UNITED STATES  
NUCLEAR REGULATORY COMMISSION  
WASHINGTON, D.C. 20555-0001

SAFETY EVALUATION BY THE OFFICE OF NUCLEAR REACTOR REGULATION  
RELATED TO ONSITE DISPOSAL OF SLIGHTLY CONTAMINATED COOLING TOWER SILT  
VERMONT YANKEE NUCLEAR POWER CORPORATION  
VERMONT YANKEE NUCLEAR POWER STATION  
DOCKET NO. 50-271

FIGURE 4

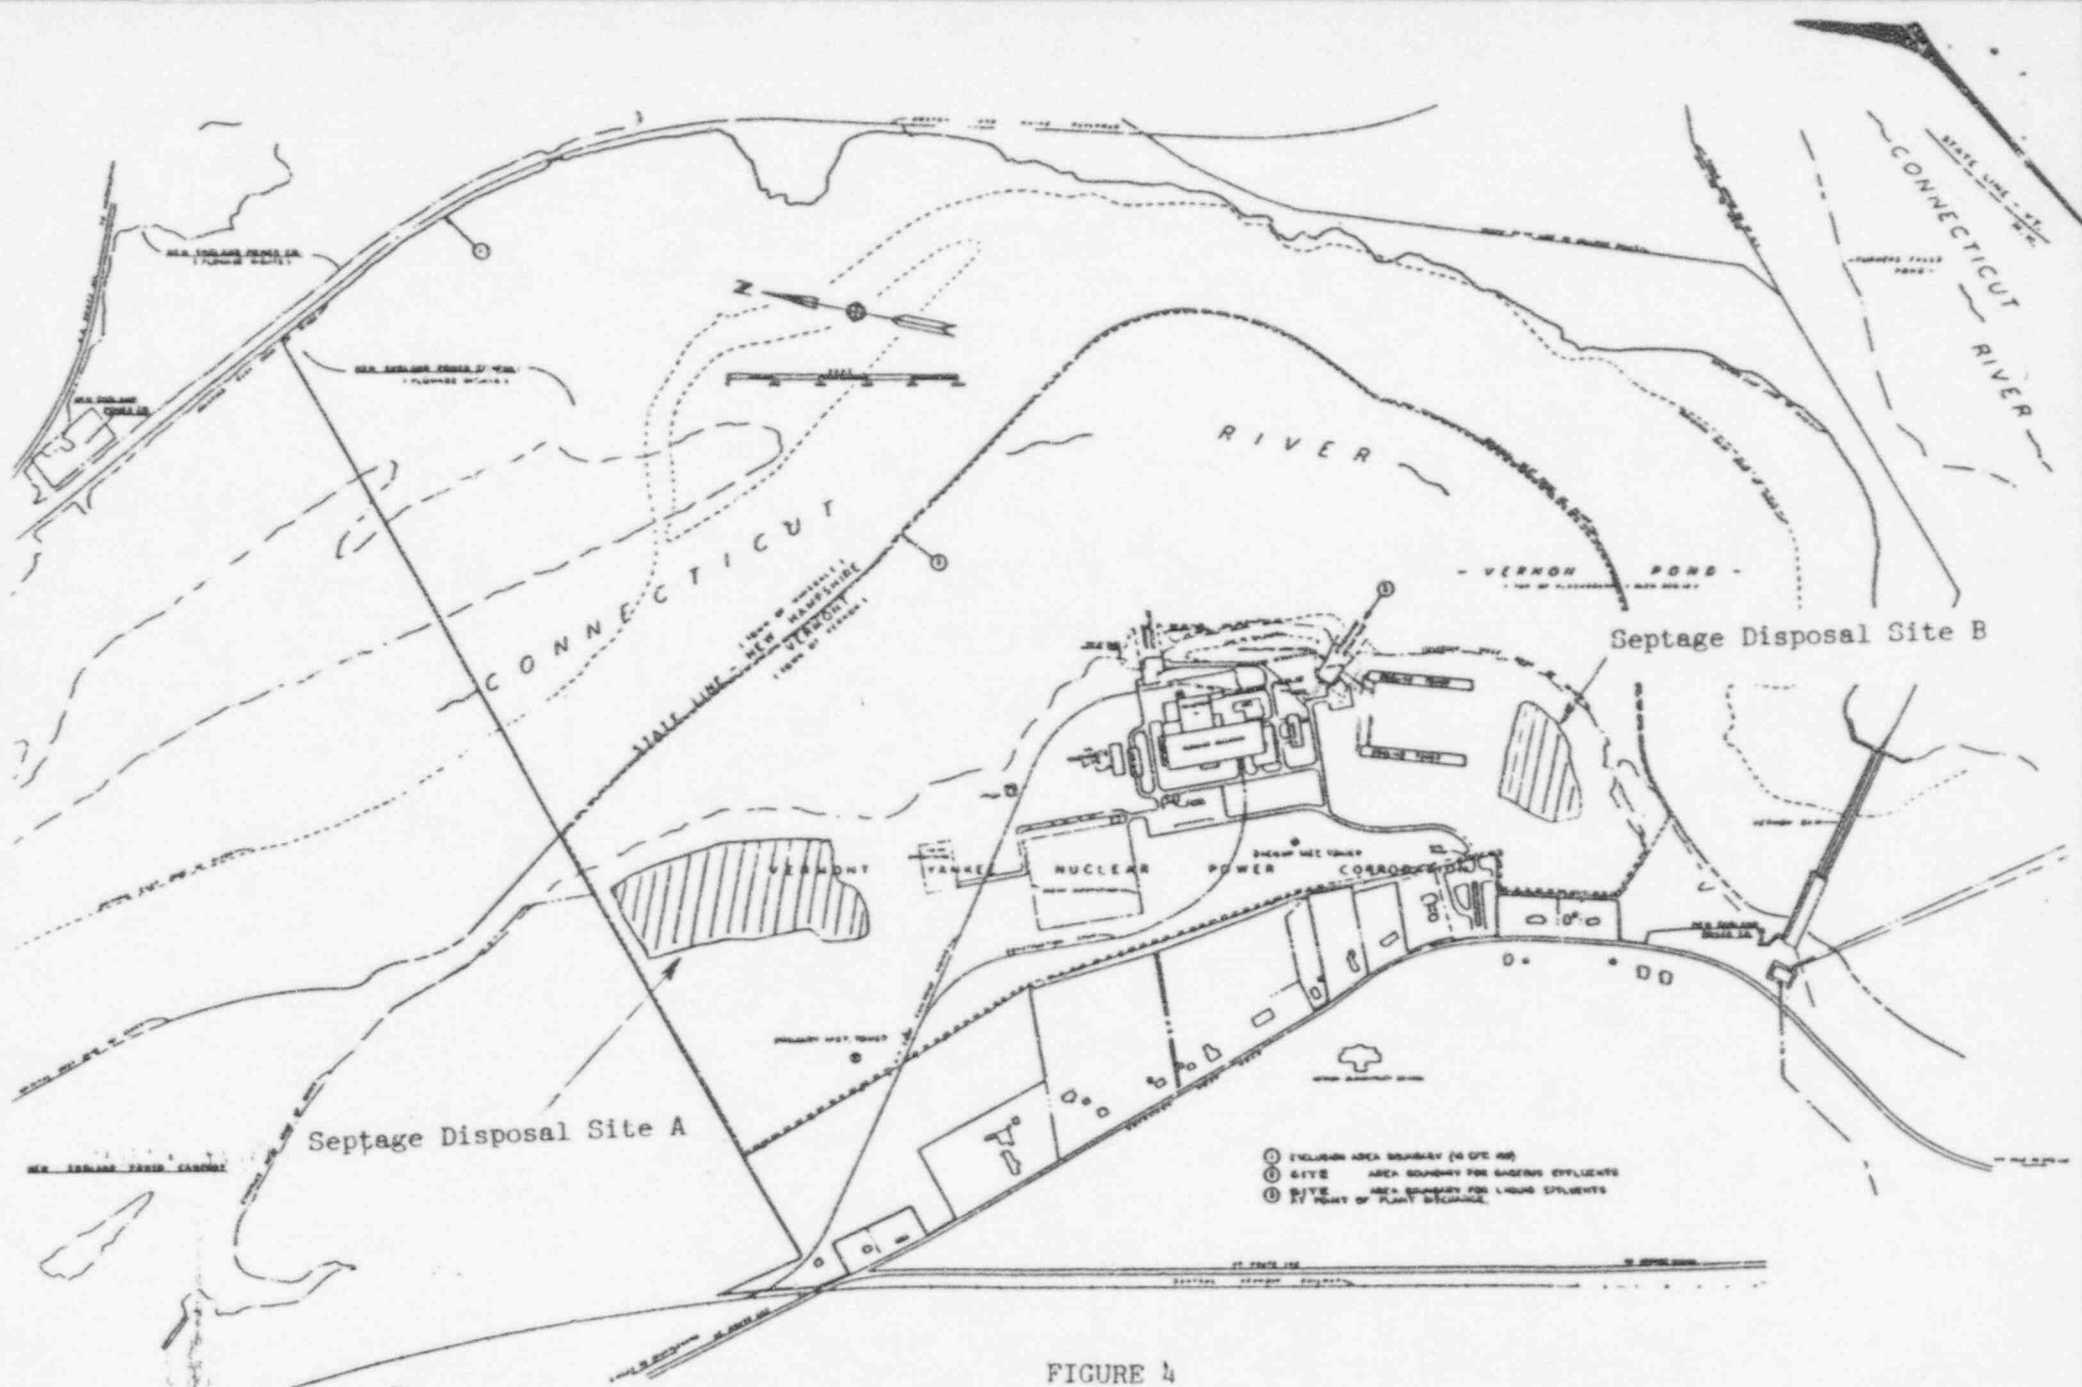
The NRC staff finds that the radiological conditions at the Vermont Yankee site (see attachment) that would result from the onsite disposal of slightly contaminated silt material, as proposed by VYNPC pursuant to 10 CFR 20.2002, and the previously approved onsite disposal of slightly contaminated septic waste material, are within the applicable boundary conditions (given above) for the disposal of licensed material. Therefore, the proposed onsite disposal of slightly contaminated silt removed from Vermont Yankee's cooling towers is acceptable.
